FED Permit

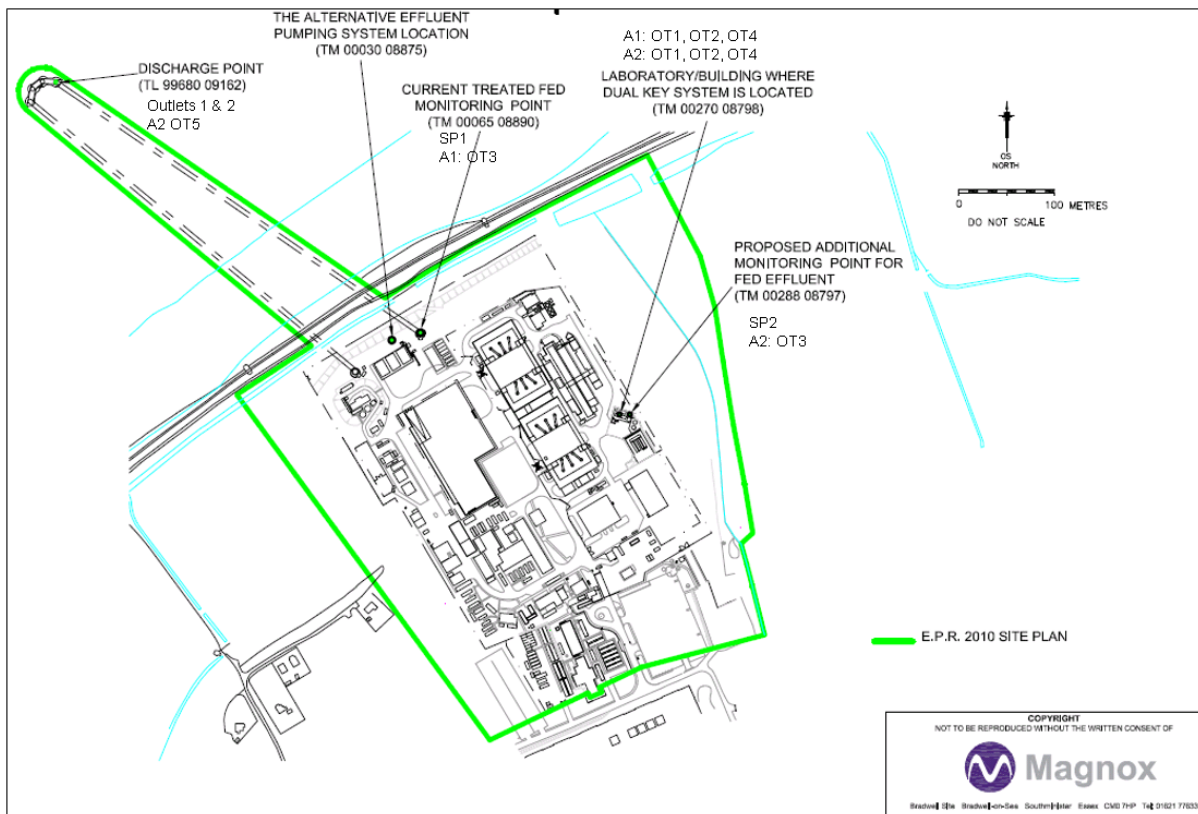
A1:OT3 is about flow monitoring of FED for both the existing discharge arrangement and when the new permit comes into force and should be at the same point as A2:OT3. Therefore, A1:OT3 should be moved to the location of SP2 (TM 00288 08797).

The current sampling point (SP1) for the FED effluent is located at the East Syphon Recovery Pit (TM 00065 08890). This will be moved to where SP2 (TM 00288 08797) when the new permit is issued for discharges using A1 (i.e. SP1 and SP2 will all be located at TM 00288 08797) and SP1 needs to be deleted.
